VISTA RIDGE

Development Plan

Vista Ridge General Development Plan Minor Amendment No. 1

VISTA RIDGE DEVELOPMENT PLAN AMENDMENT No. 3

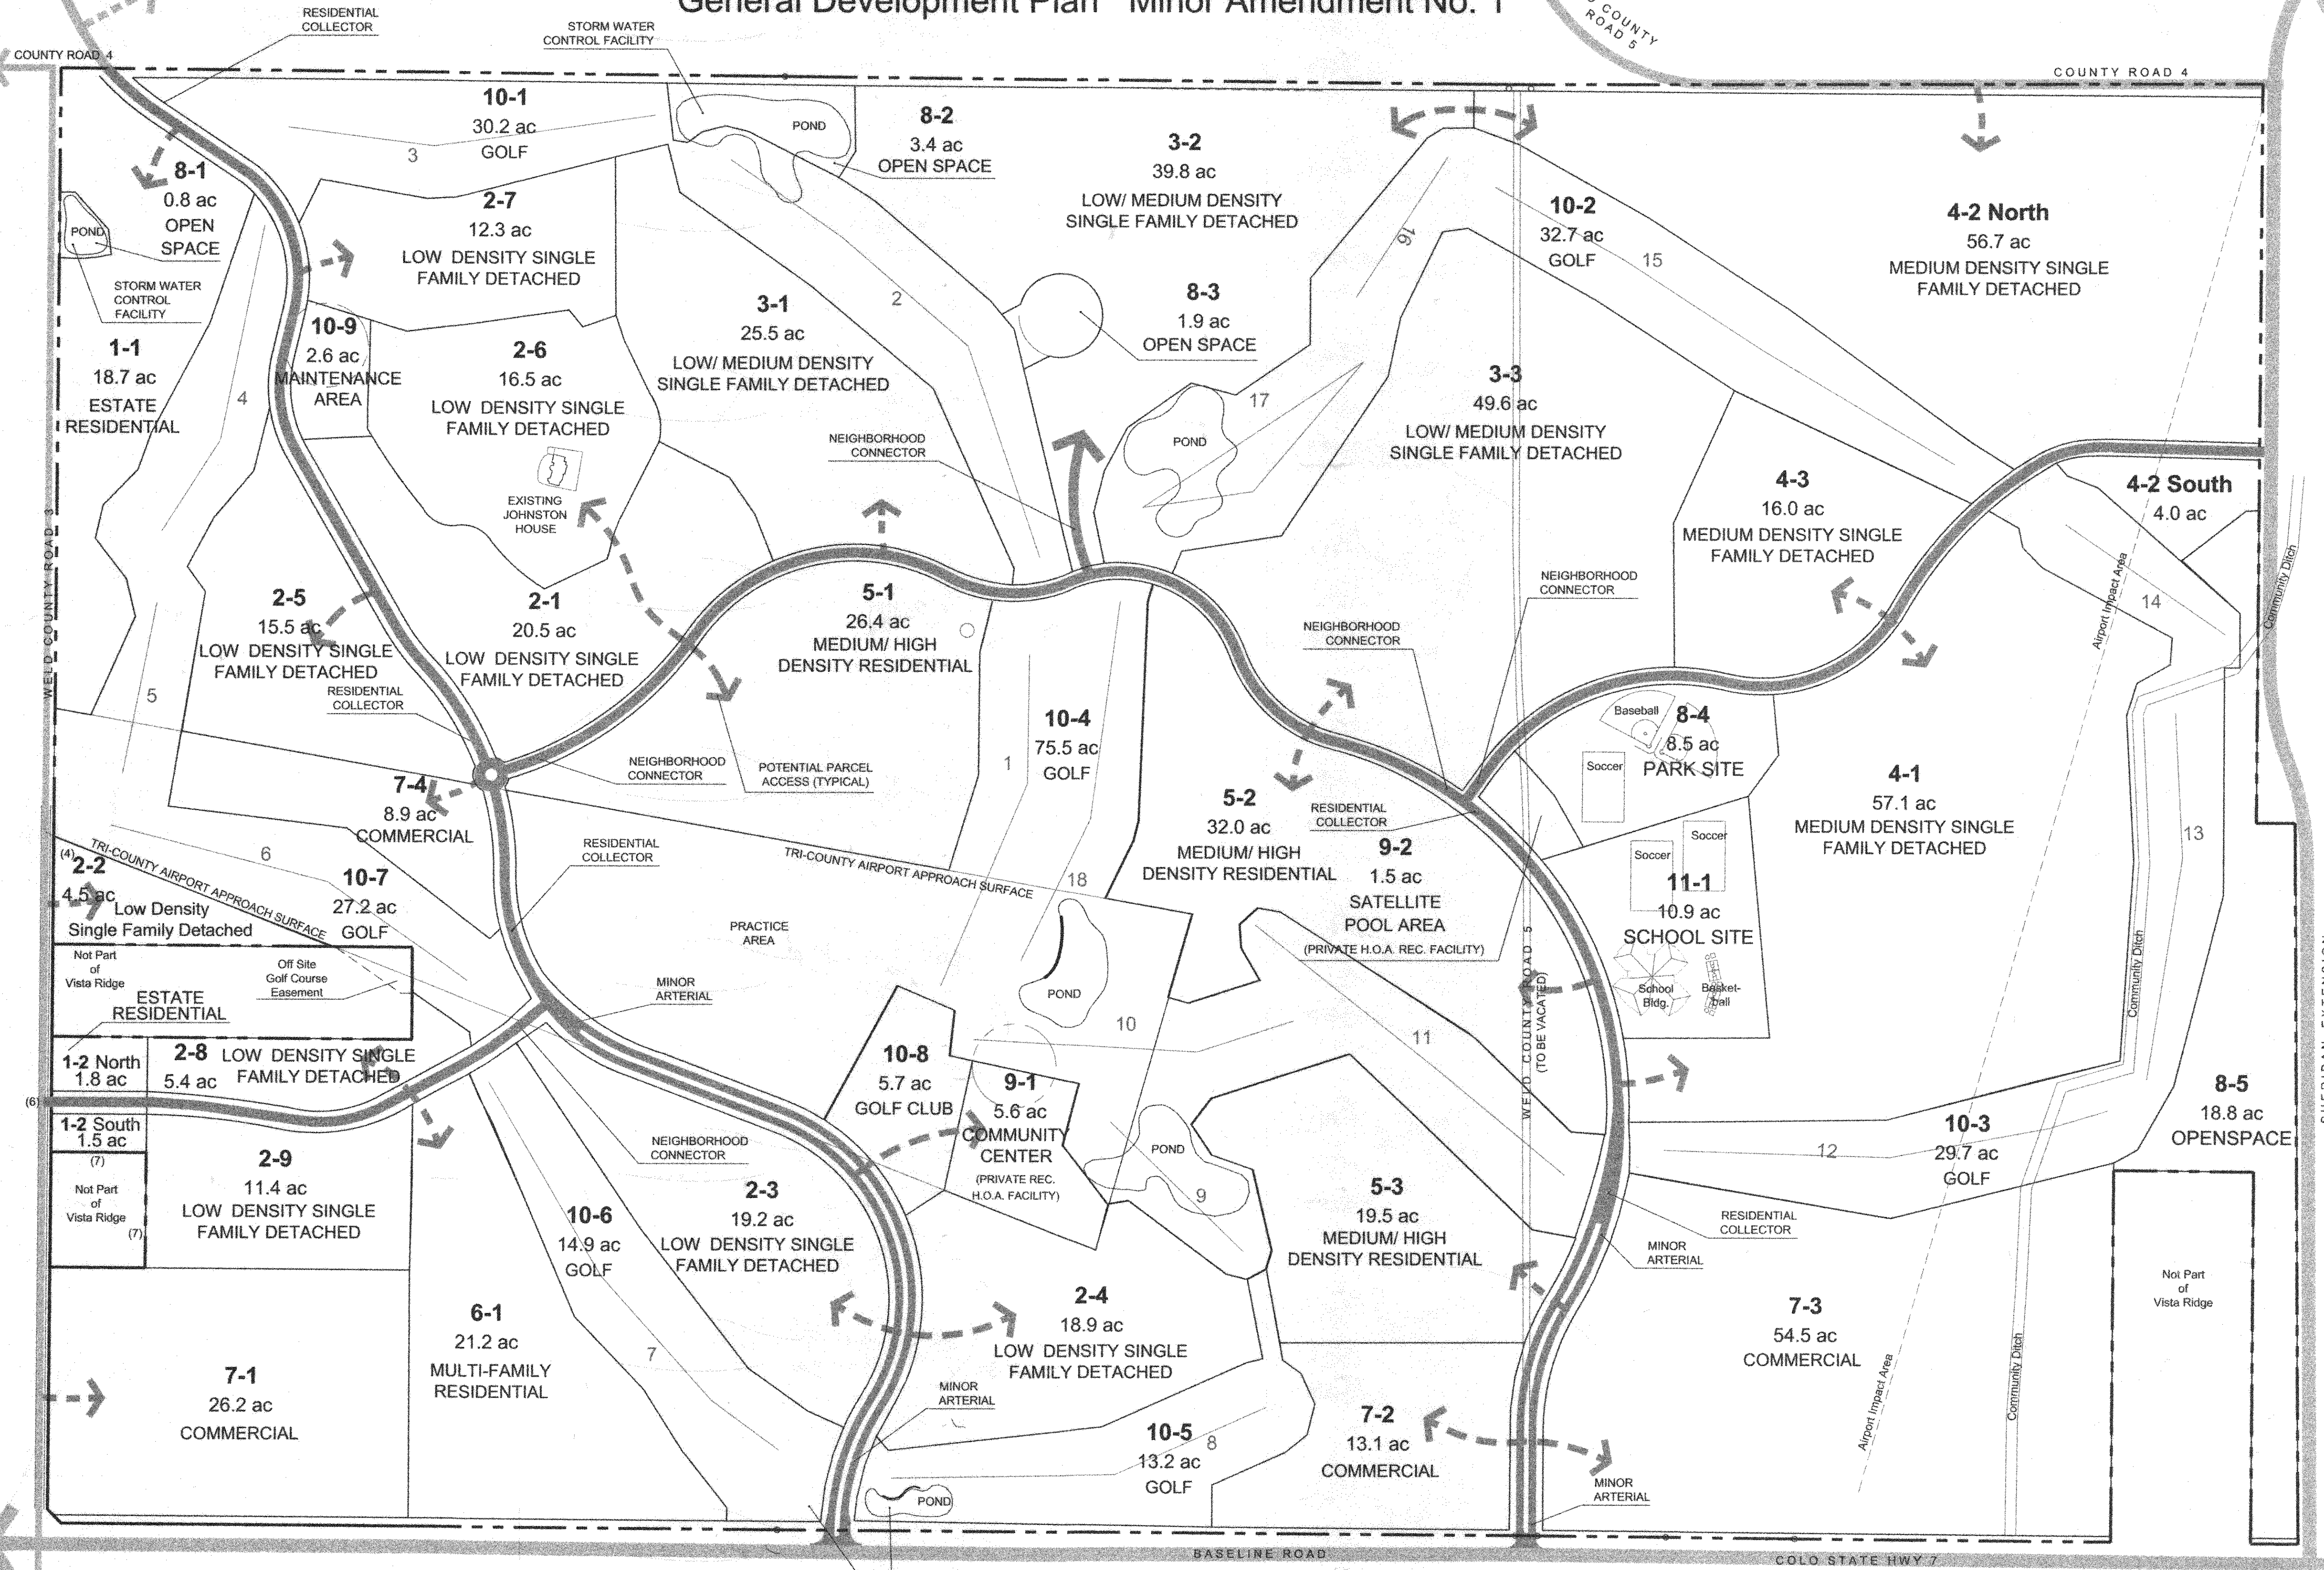
REVISION BLOCK
Realigned roadways including the north-south Minor Arterial/Residential Collector (Vista Parkway) and the east-west Neighborhood Collector (Sunset Drive) between Vista Parkway and Weld County Road 3, adjusted Parcels 1-2 North, 1-2 South, 2-1, 2-3, 2-4, 2-5, 2-7, 2-8, 2-9, 10-1, 10-7, and 10-9.
December 07, 2001

REVISION BLOCK

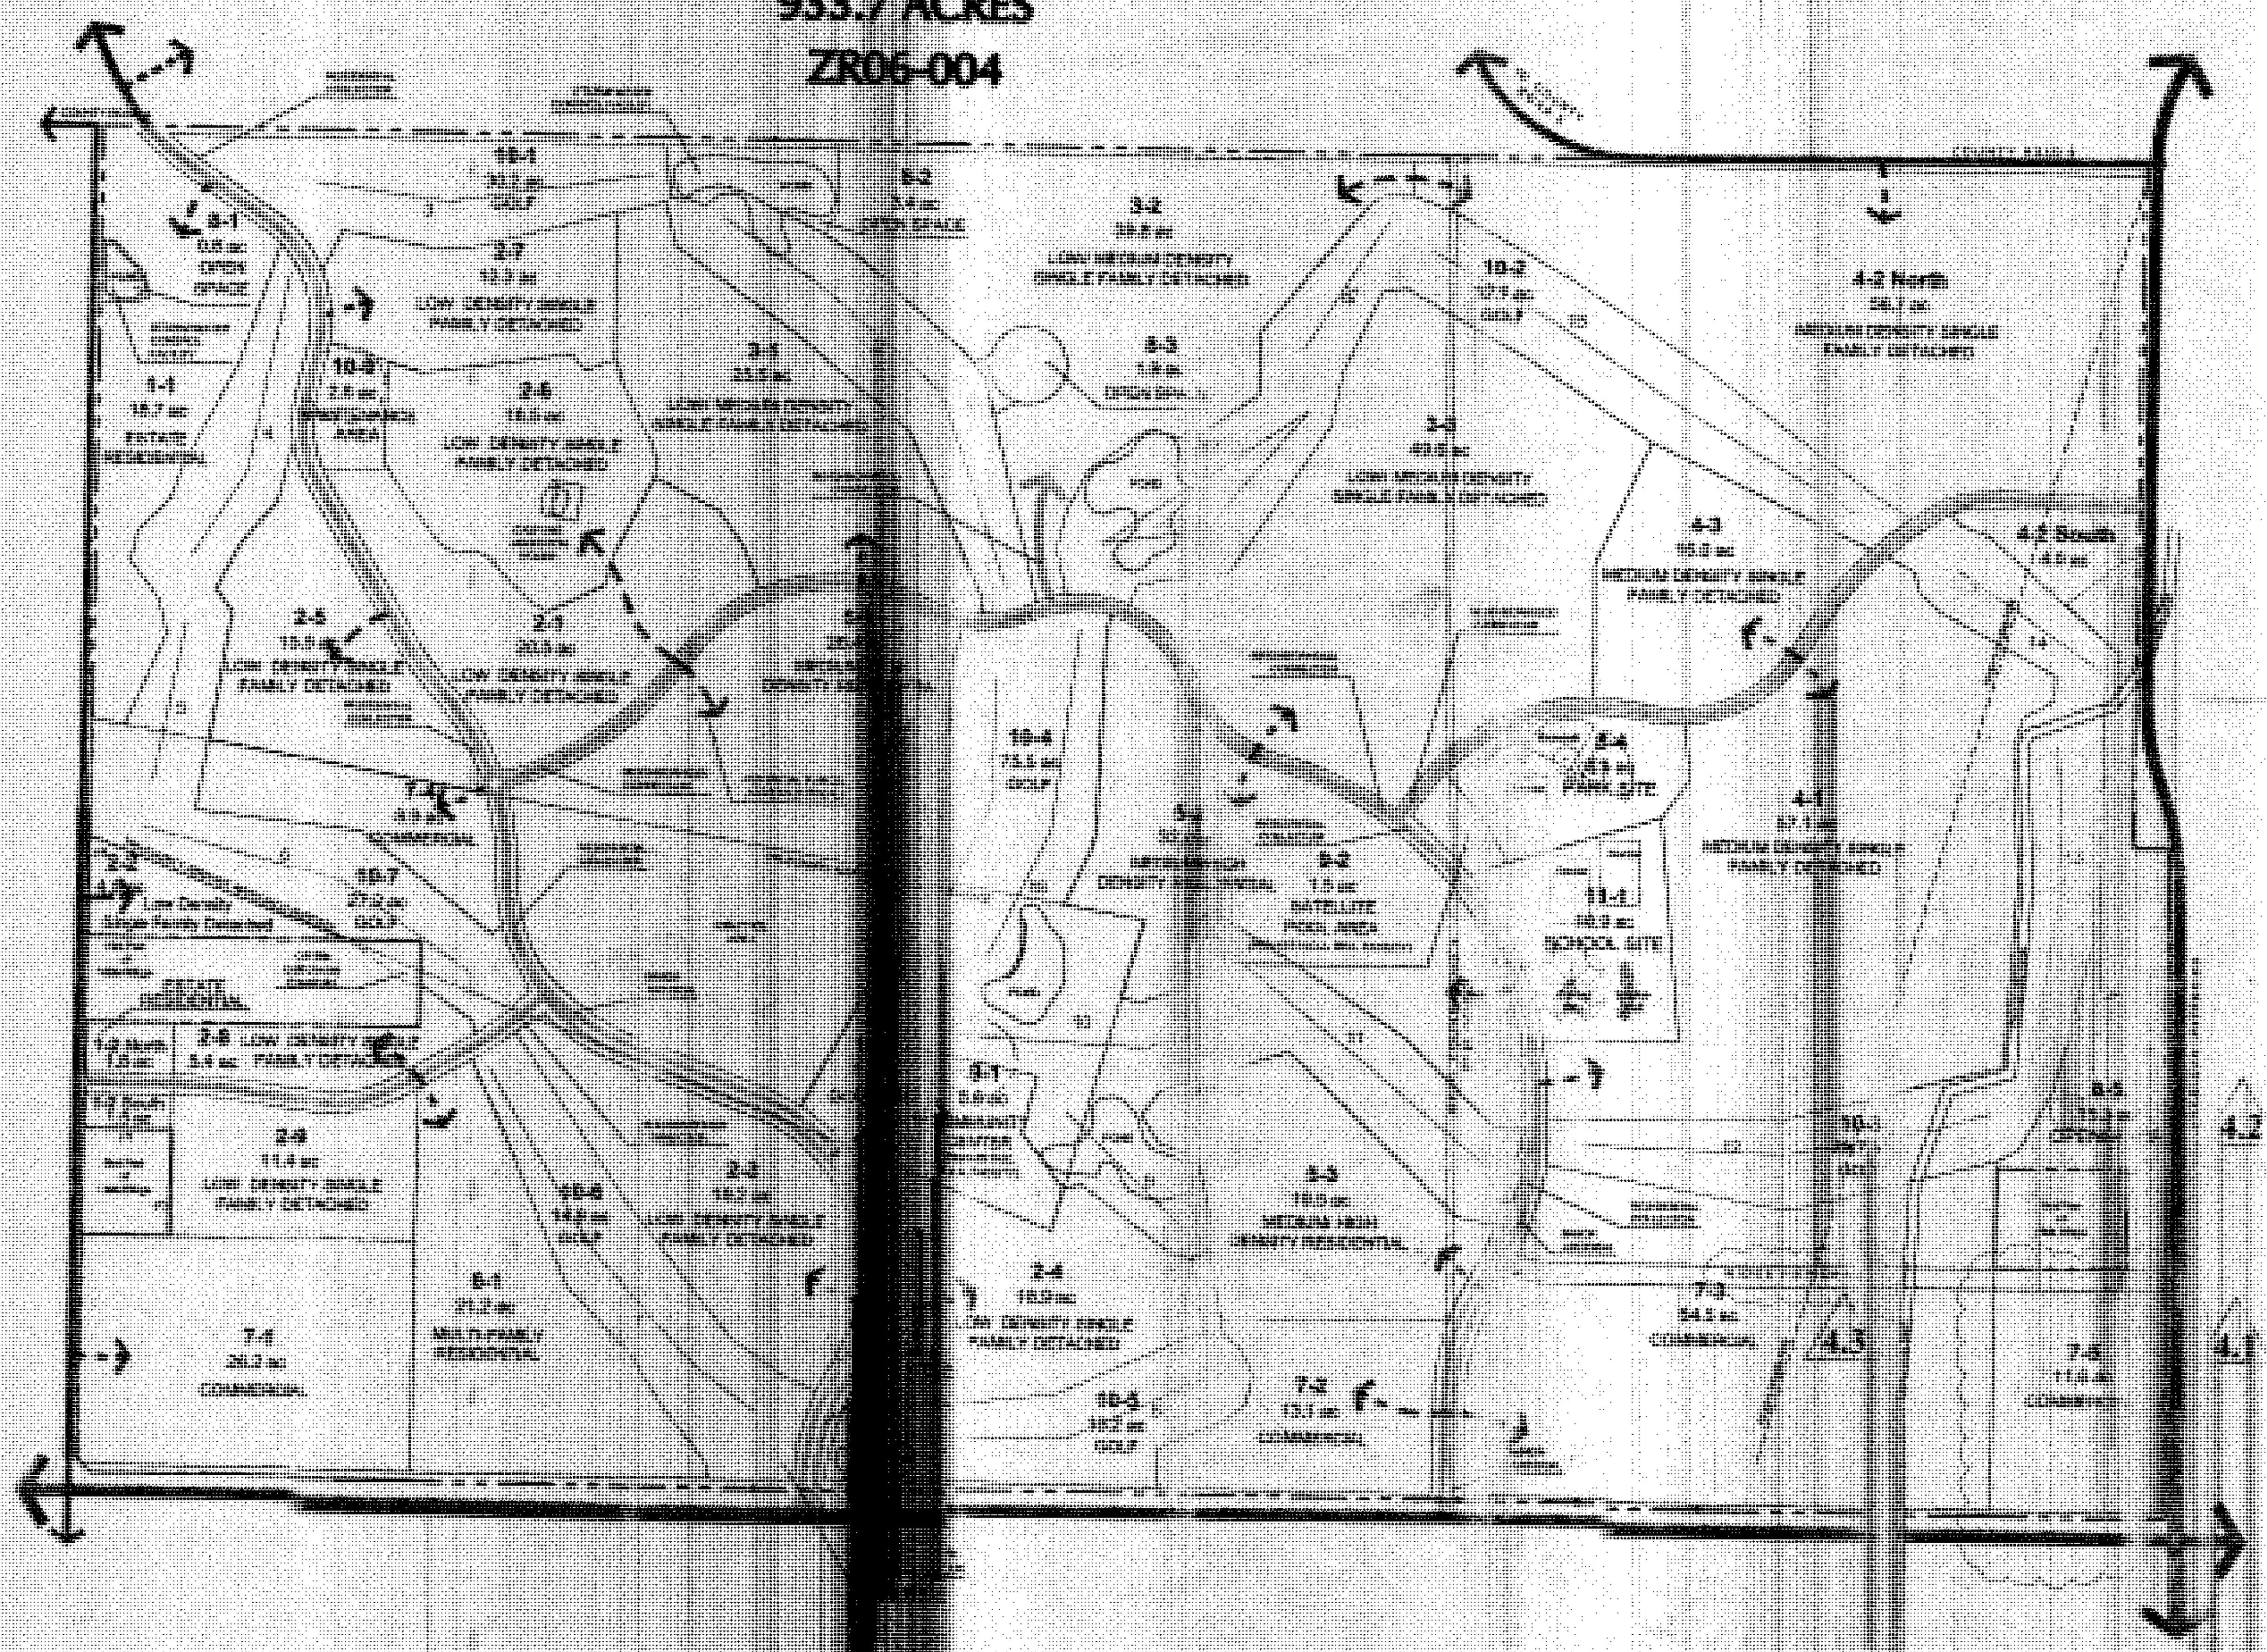
NO.	DESCRIPTION	DATE
1	Added Commercial Planning Area, PA 7-5, (11.5 acres) to the Development Plan.	10/1/00
2	Reduced Open Space Planning Area, PA 5-5, (3.3 acres) to the Development Plan.	10/1/00
3	Added RidgeView Drive.	10/1/00

1 - Added Commercial Planning Area, PA 7-5, (11.5 acres) to the Development Plan.

2 - Reduced Open Space Planning Area, PA 5-5, (3.3 acres) to the Development Plan.

3 - Added RidgeView Drive.

REVISION BLOCK

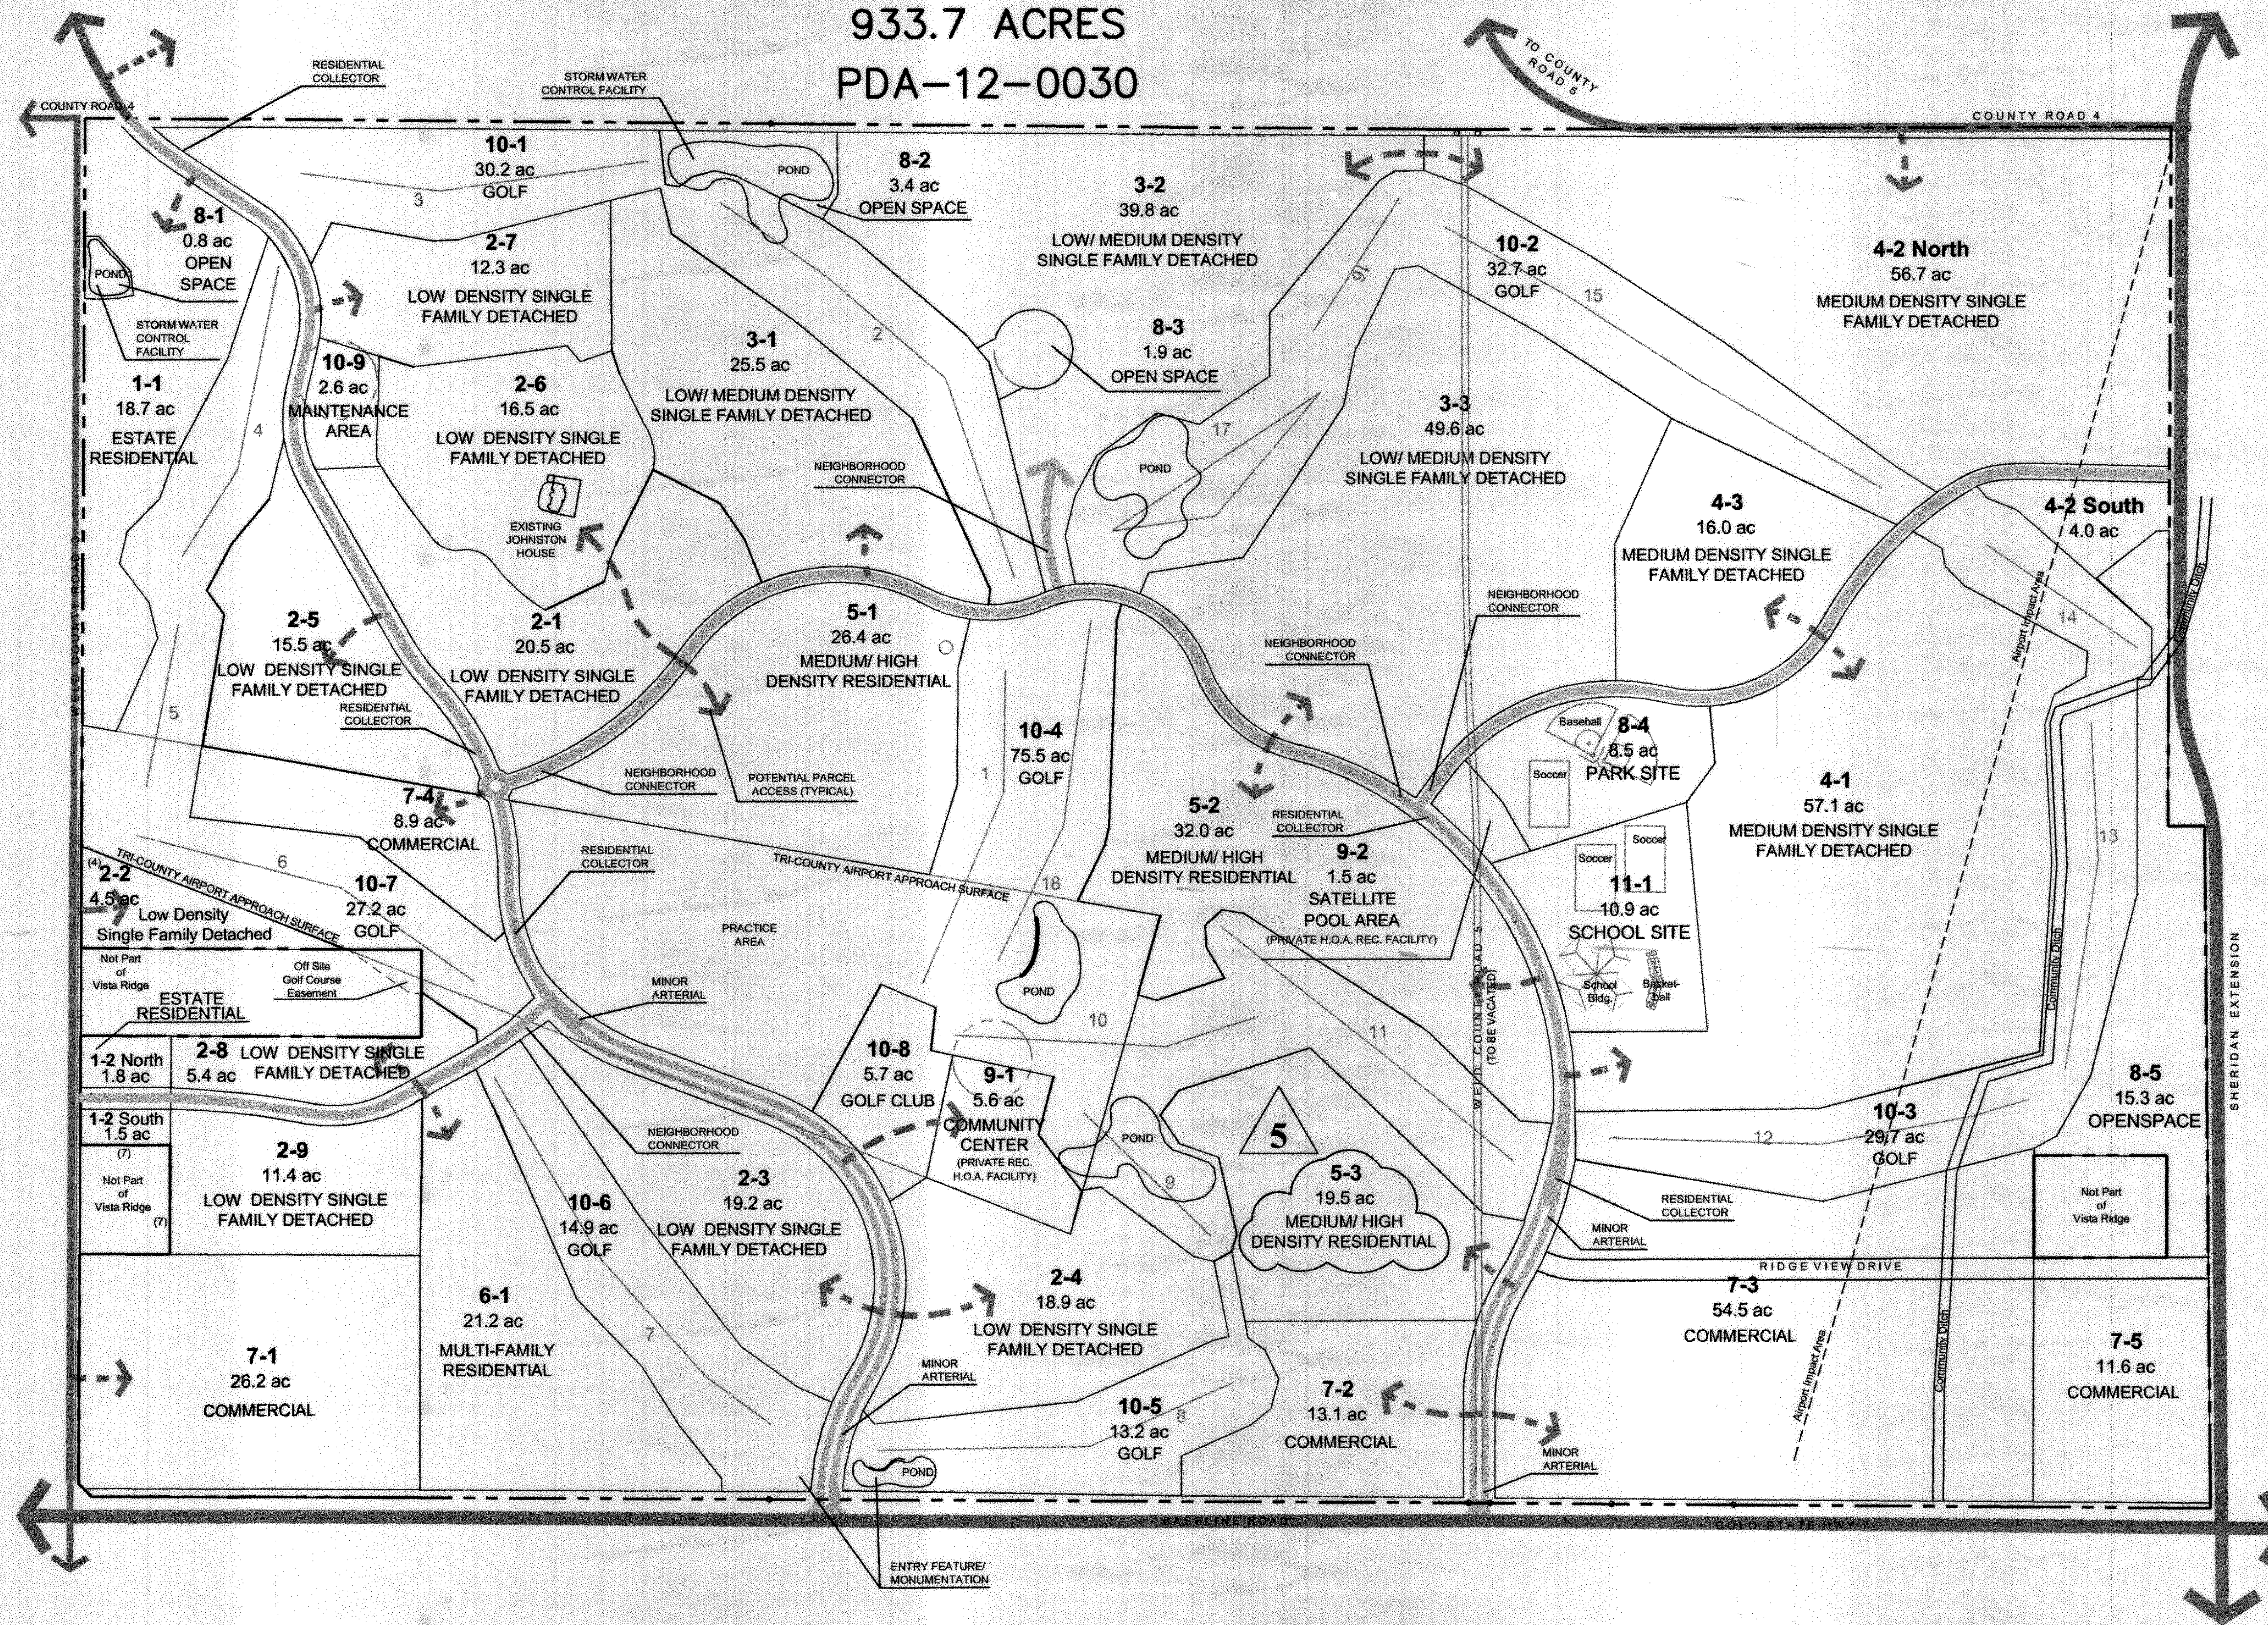
1- Planning area 5-3 revisions.
